# Access Compliance Report Public Rights-of-Way (Curb Ramps)

Main Street: GERTRUDE\_DR Cross Street: KENSINGTON\_RD Location: NW

ADA ID: RPRK211220141233 Ramp Type: Type 1 - Perpendicular Diagonal Initial Pass/Fail: Pass Overall Compliance: No Severity Score: 10

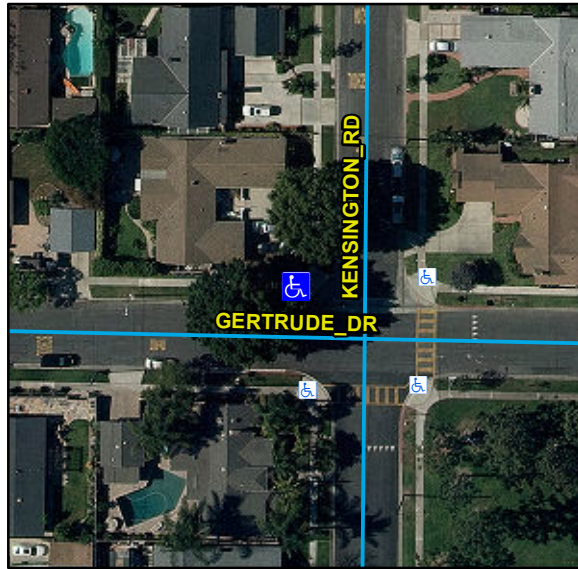
Remove & Replace Curb Ramp With Two New Directional Ramps or Equivalent. Gutter Ponding Observed.

| Compliance | Description                           | Data | Compliance | Description                   | Data   |
|------------|---------------------------------------|------|------------|-------------------------------|--------|
| No         | Landing Run Slope (%)                 | 3.7  | N/A        | Flare Traversable RT          | No     |
| Yes        | Landing Cross Slope (%)               | 0.7  | No         | DWS Provided                  | No     |
| No         | Gutter Ponding                        | Yes  | Yes        | Curb Slope                    | 1.9    |
